**Addendum 1 to the January 2025 White Paper:
Comprehensive Opposition to CUP2024-10001: Proposed Communication Tower in
Starwood PD**

**Addendum 1
Environmental, Due Diligence, Visual, and Compliance Concerns Regarding the Proposed
Communications Tower**

Prepared by: David Grau

Date: January 2025

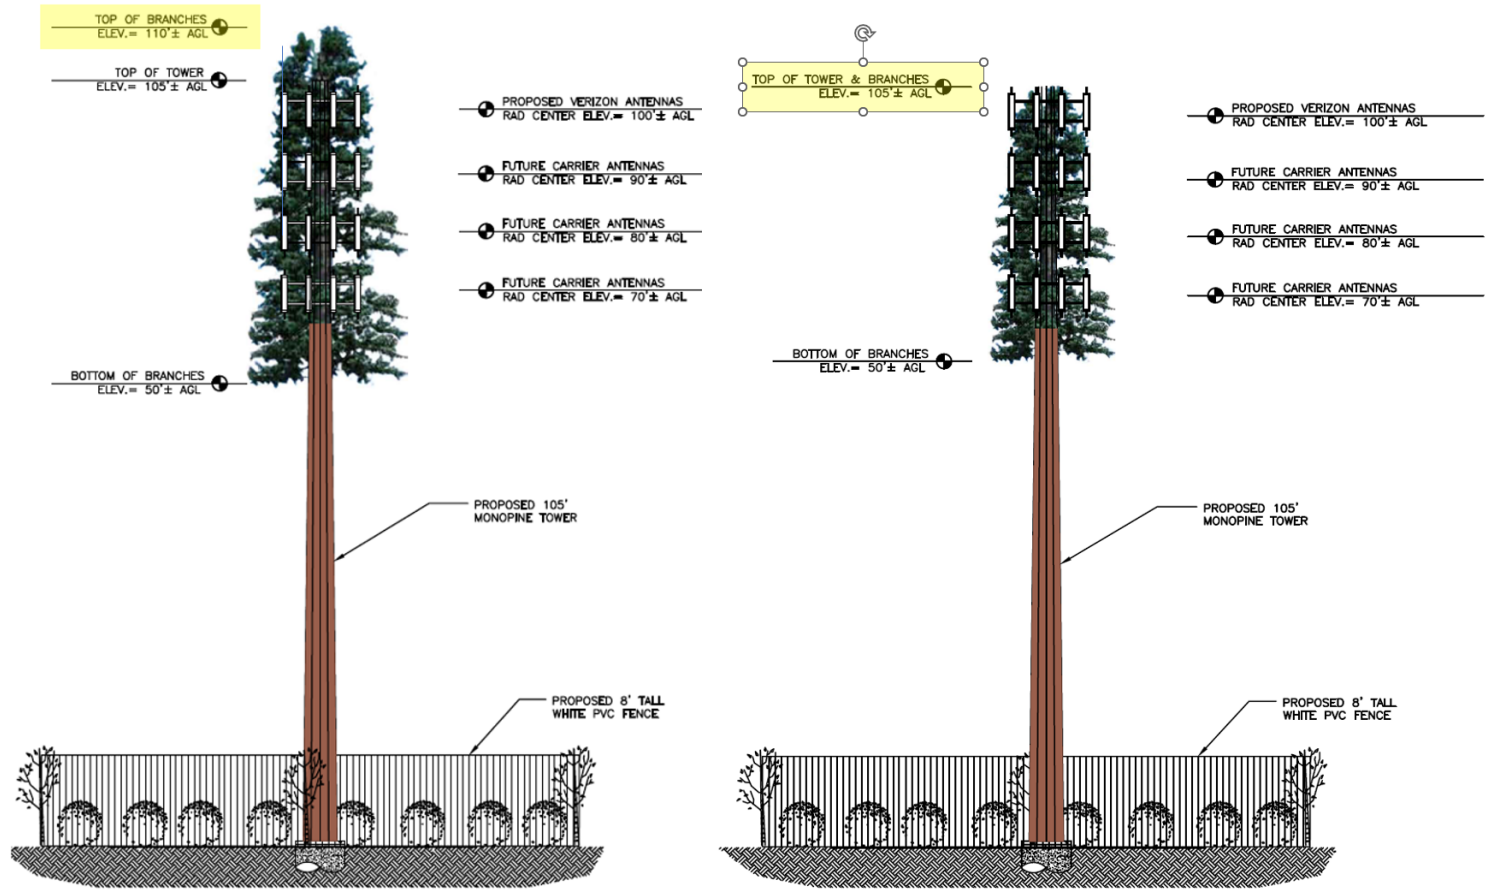
- **Aesthetic Sacrifices to Meet Ordinance 58.844:** The applicant revised drawings between 11/20/24 and 01/03/25 to reduce the tower's height from 110 feet to 105 feet in an effort to address setback requirements from residential lots. However, this does not resolve the issue of the tower's placement atop a residential component in the PD. Furthermore, the revision fully exposed the antennae on the highest portion of the tower and removed previously proposed, though inadequate, camouflage. This alteration is contrary to the intent of zoning requirements and contradicts the policies of the growth management plan. Graphics illustrating this change and its impacts on camouflage are provided.

Visual Evidence of Aesthetic Sacrifices:

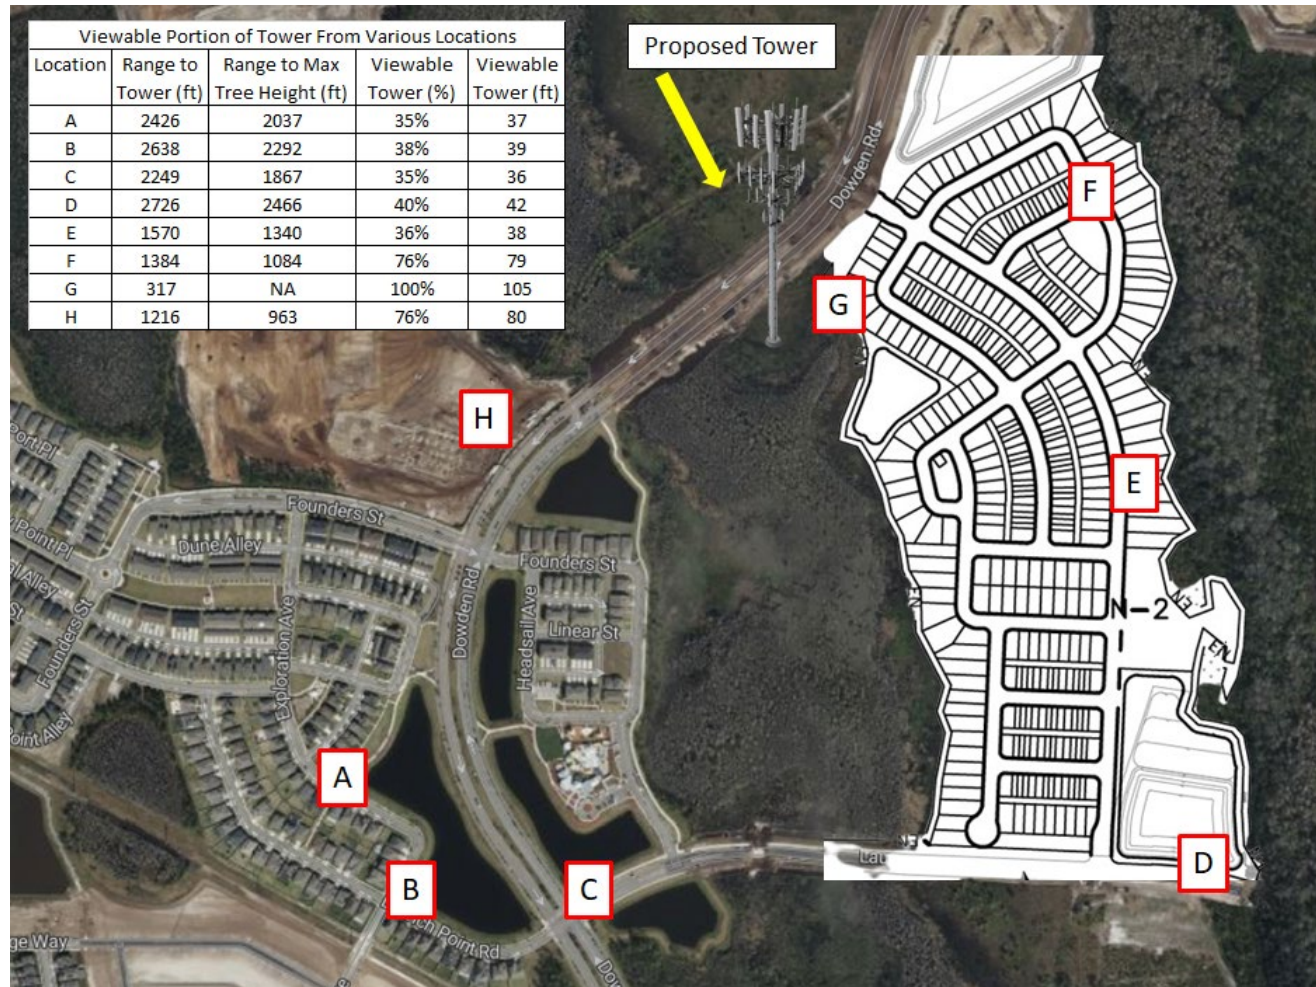
The visual analysis reveals the significant impact of the proposed tower on the community skyline:

- **High Visibility from Close Ranges:** Locations F, G, and H show that over 75% of the tower is visible above the tree line, significantly disrupting the skyline.
- **Persistent Impact from Greater Distances:** Locations A and D reveal that 35–40% of the tower remains visible, even from farther vantage points.
- **Enhanced Methodology for Analysis:**
 - **Tree Height Verification:** Measurements of tree line heights were calculated using trigonometry and verified with drone altitude data for accuracy.
 - **Triangulation:** Tree and tower heights were triangulated with verified data to analyze visibility from key public spaces.
 - **Simulated Altitudes:** Images were captured from a drone at multiple altitudes to confirm visibility across large areas.
 - **Community Impact Analysis:** Highlights the lack of natural screening for homes closest to the tower.

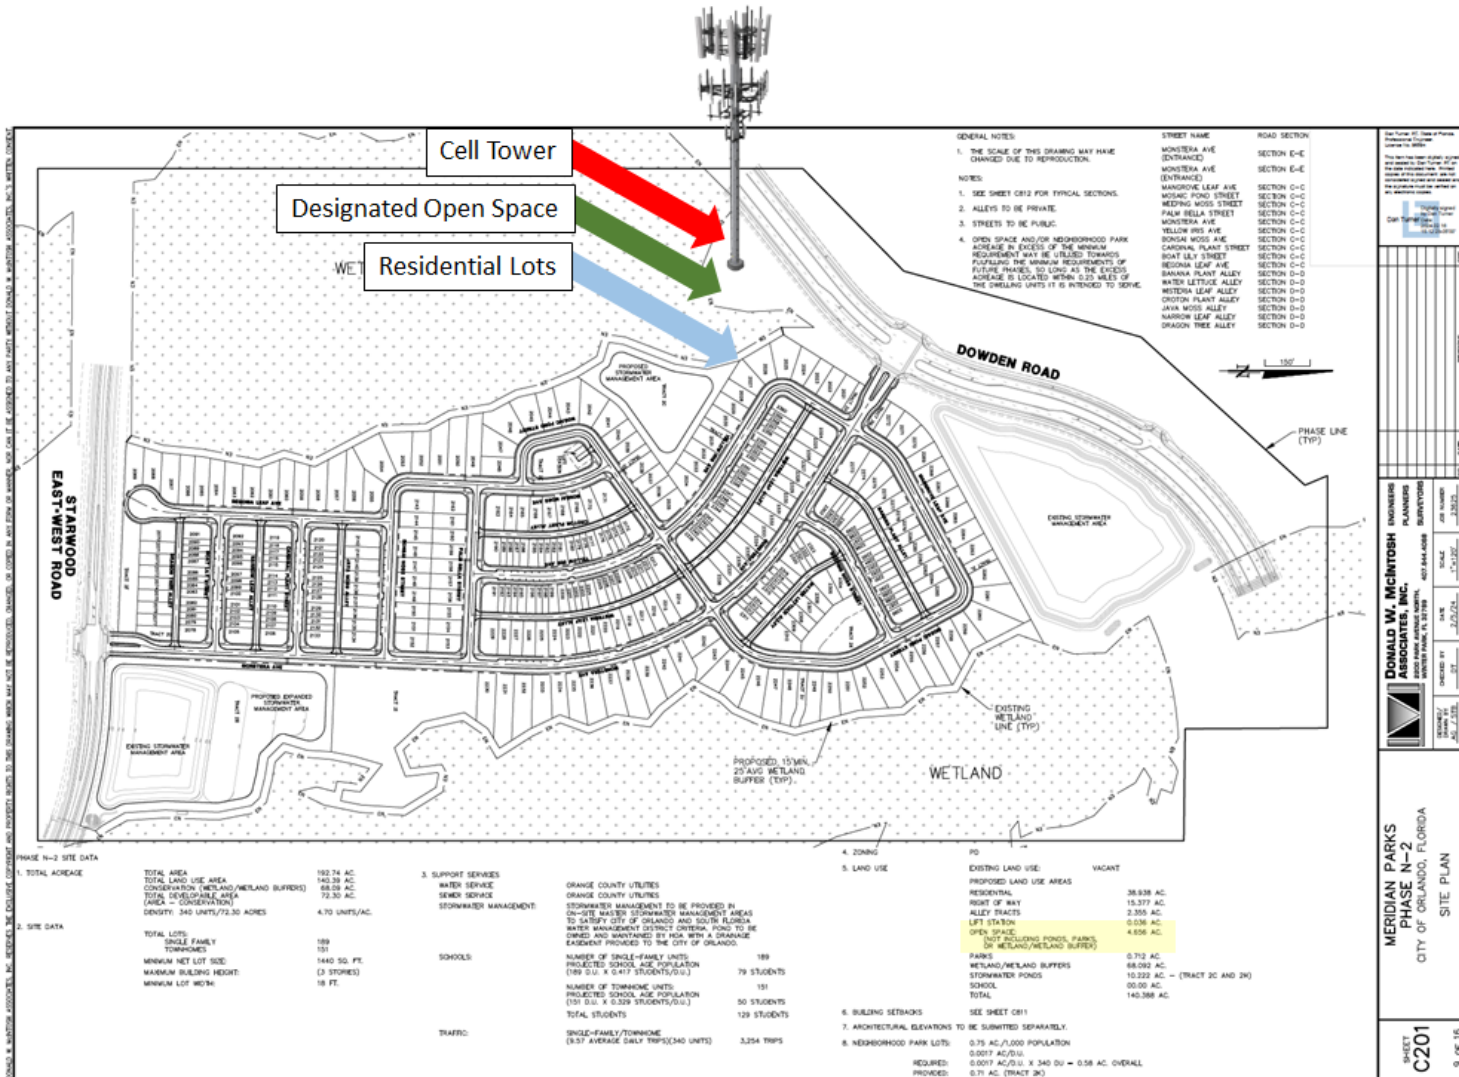
The proposed 105-foot cell tower requires a 315-foot setback from residential components to comply with Ordinance 58.844. However, the applicant's revised plans fail to meet this standard in several significant ways:

Ordinance 58.844: This image highlights the City of Orlando’s requirement that cell towers maintain a minimum setback of 300% of their height from any residential component of a Planned Development (PD). The proposed tower’s placement in open space, with a residential use code, in a PD, and abutting residential properties fails to uphold this standard, undermining the ordinance’s intent to protect residential areas from industrial impacts.

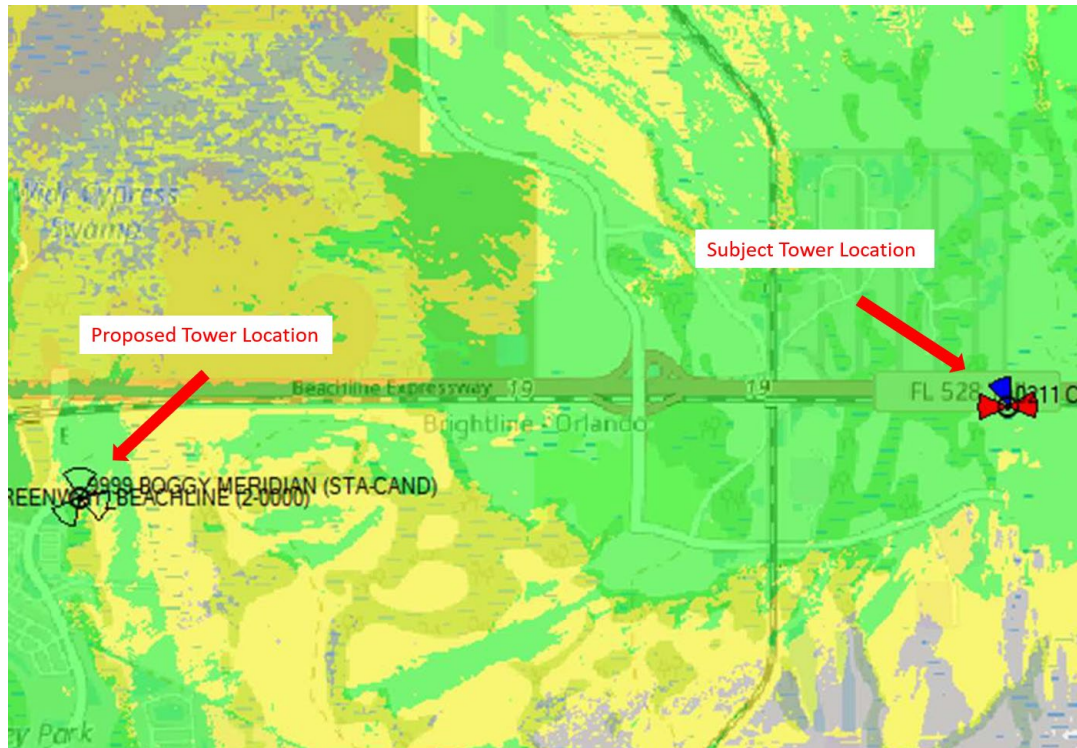
The Verizon RF package submitted with the application contains significant errors and lacks the transparency necessary to support claims of necessity and site suitability. These deficiencies highlight the need for a thorough review of the entire proposal, as the RF package forms the technical foundation of the application.

- **Sunbridge Community Error:** The RF package inaccurately states, "The primary objective for this project is to improve service quality in the residential and commercial properties of the new community of Sunbridge." However, Sunbridge is located approximately 7 miles from the proposed site, making this claim fundamentally flawed. This error casts doubt on the validity of the RF package's analysis and its alignment with the goals of the Starwood PD community.
